MODIFICATION REQUEST: Googong Township Integrated Water Cycle Project

Stage 1 Project Approval Modification 2 (MP08_0236 MOD 2)

Additional Discharge Point to Googong Creek

Secretary's Environmental Assessment Report
Section 75W of the
Environmental Planning and Assessment Act 1979

Figure 3: Modified project layout (Source: Modification to Approved Project: Googong Township Integrated Water Cycle Project, March 2014)

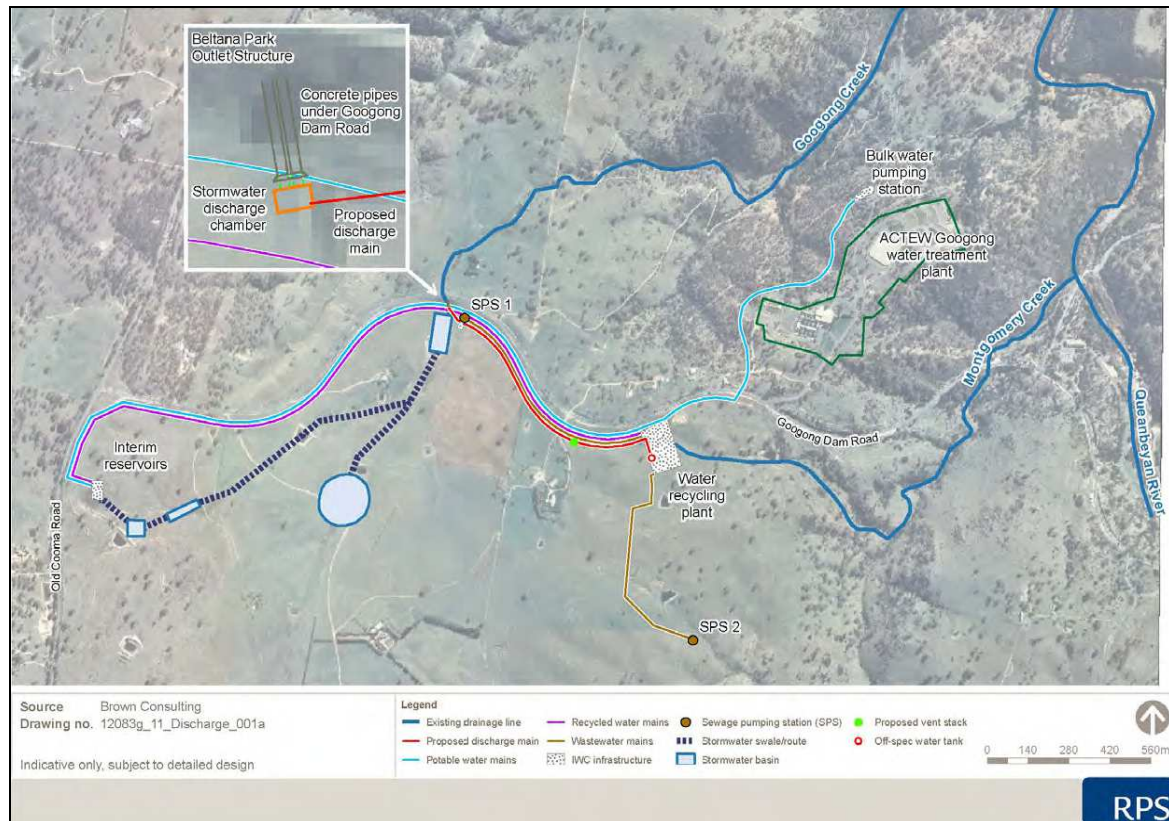
The modification proposes to add a third environmental release discharge point near Sewage Pumping Station 1, within Beltana Park on the northern side of Googong Dam Road. The proposed modified layout is shown in **Figure 1**. Key aspects of the proposed modification are summarised in **Table 1**.

Aspect	Description
Outlet structure	New outlet structure within Beltana Park/adapt existing outlet structure within Beltana Park, including connection of new discharge main to stormwater chamber.
Off spec water tank	30kL tank within the water recycling plant to enable water that does not meet recycled water specifications to be held and either retreated or pumped to the discharge location.
Emergency discharge tank	330kL tank at the discharge location to enable water recycling plant to be held prior to release or transfer back to water treatment plant for retreatment. Tank has eight hours capacity.
New discharge main	New main pipe from off spec water tank in water recycling plant to emergency discharge tank at discharge location. Pipe consists of 326m long 300 mm diameter rising main and 630m long 450mm gravity main.
Vent stack	6-14m high 250mm vent stack above the connection of the rising main to the gravity main to mitigate potential odour impacts.
